Re: Pierpont Wastewater System Improvements  
Helms A-6830

## **ADDENDUM NUMBER 1**

The following modifications are made to the plans and specifications for the Pierpont Wastewater System Improvements project.

ALLEY BETWEEN 1ST & 2ND ST  
PLAN AND PROFILE SHEET  
(STA. 59+00 TO STA. 63+00)  
PIERPONT WASTEWATER  
SYSTEM IMPROVEMENTS  
PIERPONT, SOUTH DAKOTA

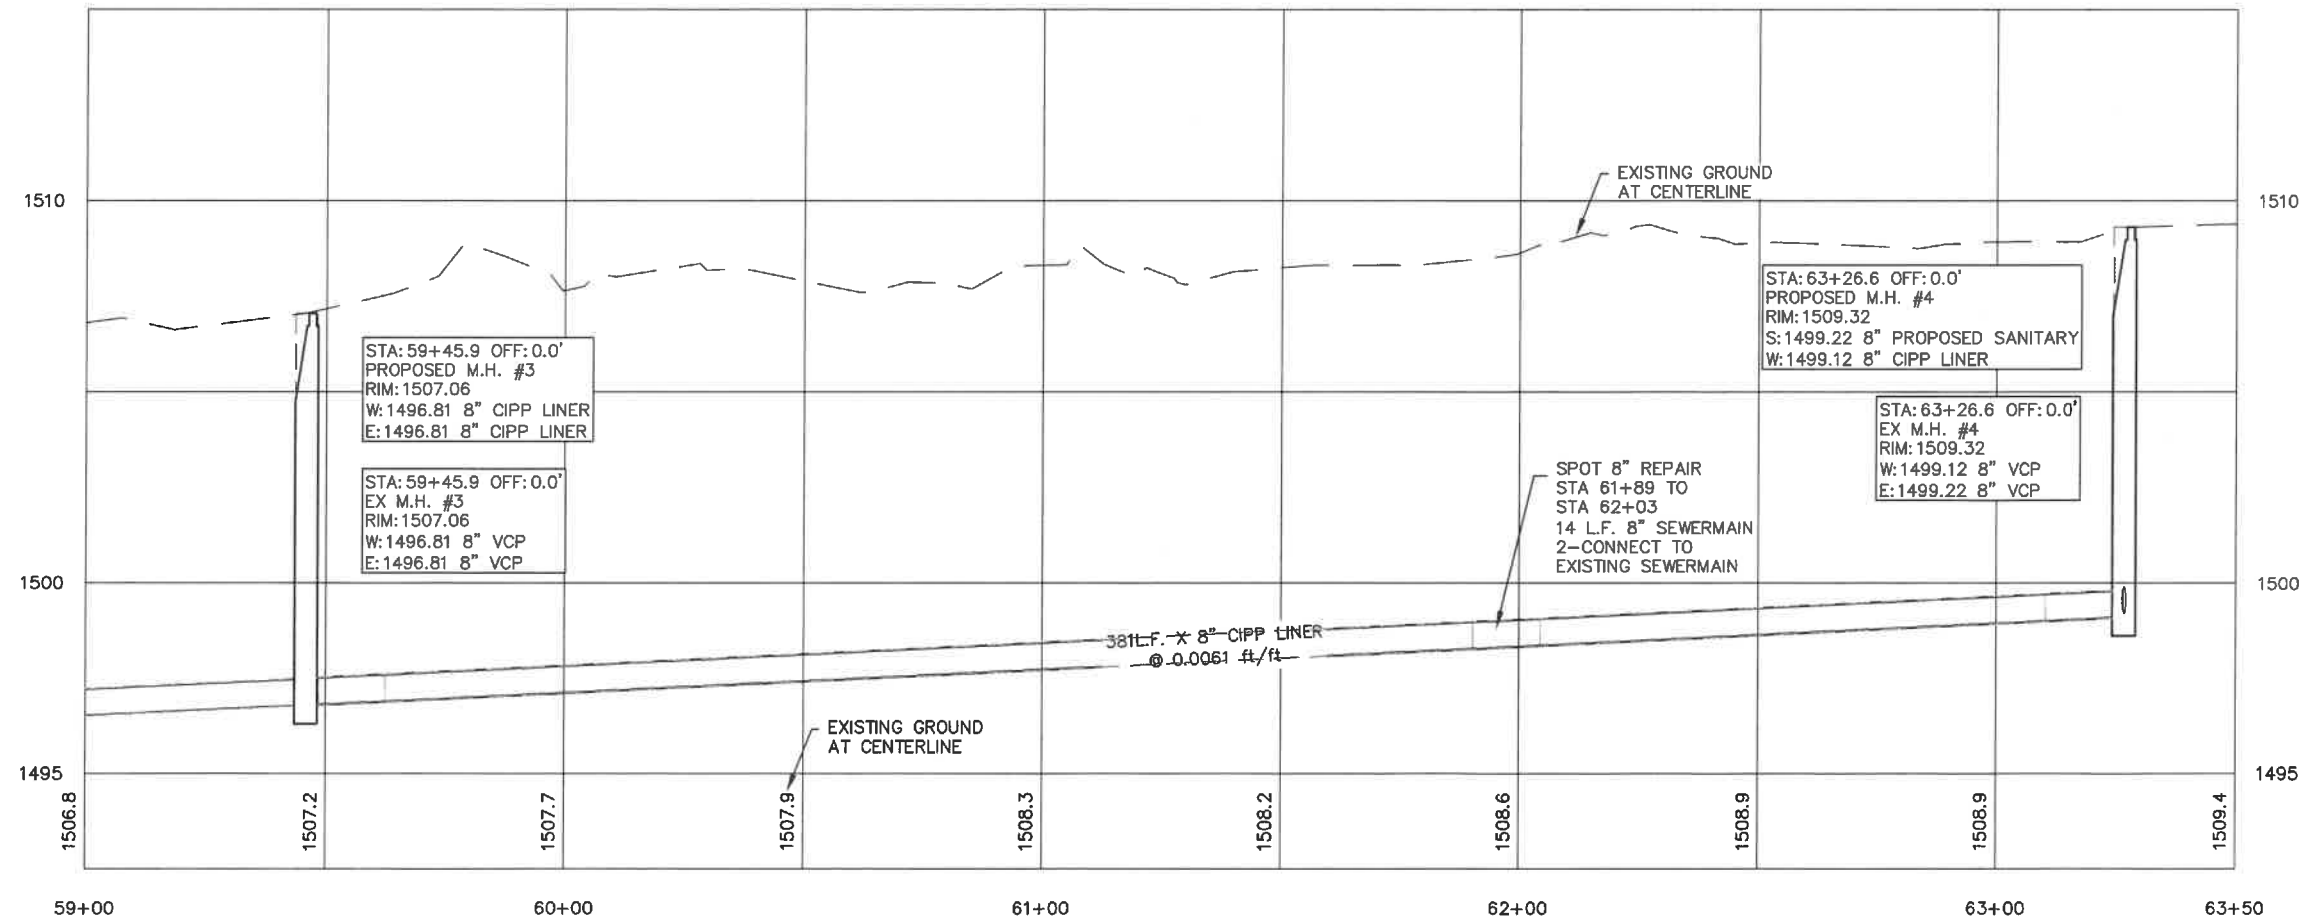
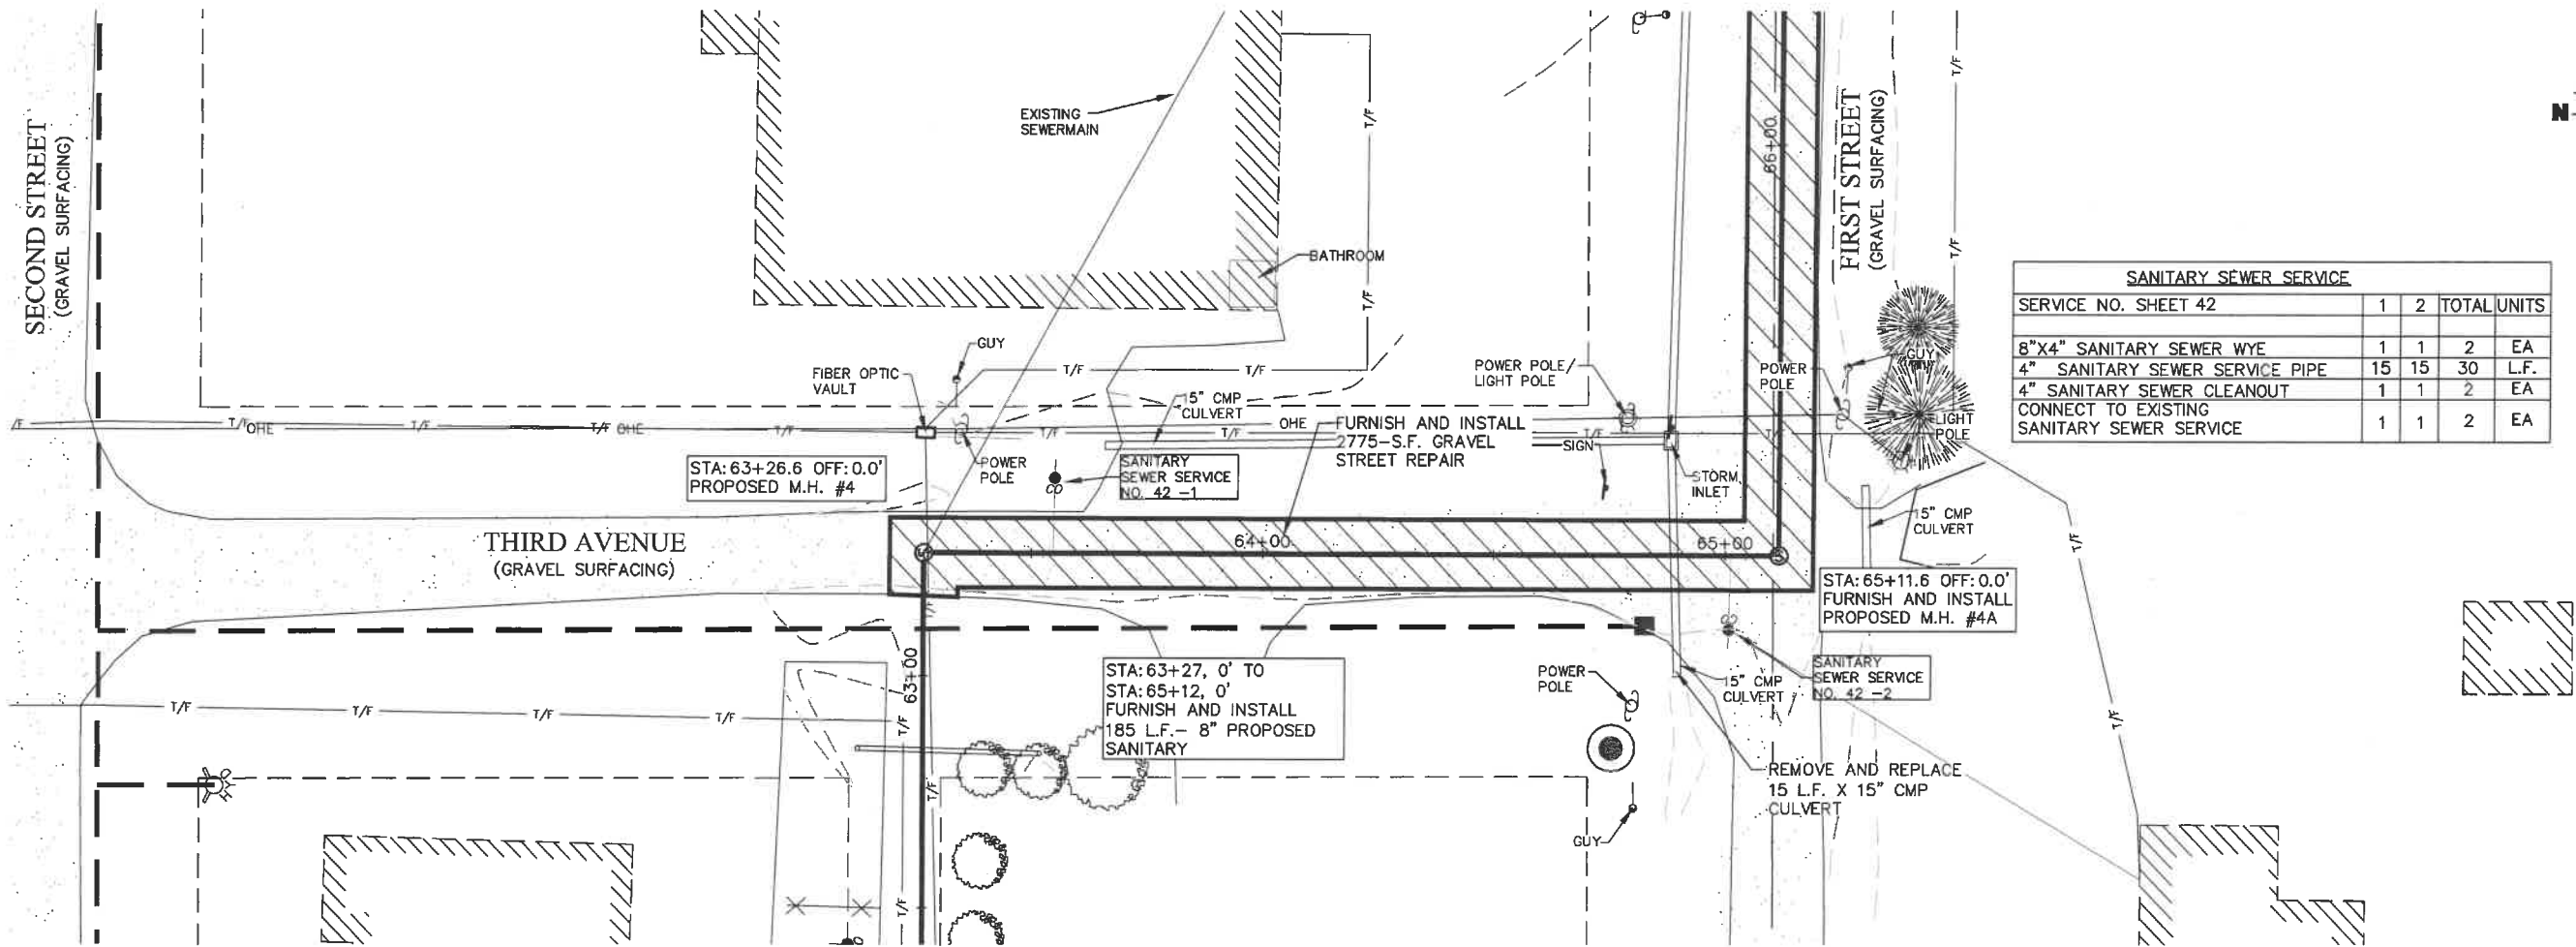
**10.) Construction Plans, Sheets 41, 42, 43, 44 of 64 – Revision of entire sheet**

Please remove and replace Plan Sheets 41, 42, 43, and 44 with the attached revised Plan Sheets. (Revisions made to the grade of the proposed sanitary sewer pipe and invert elevations of proposed MH #4)
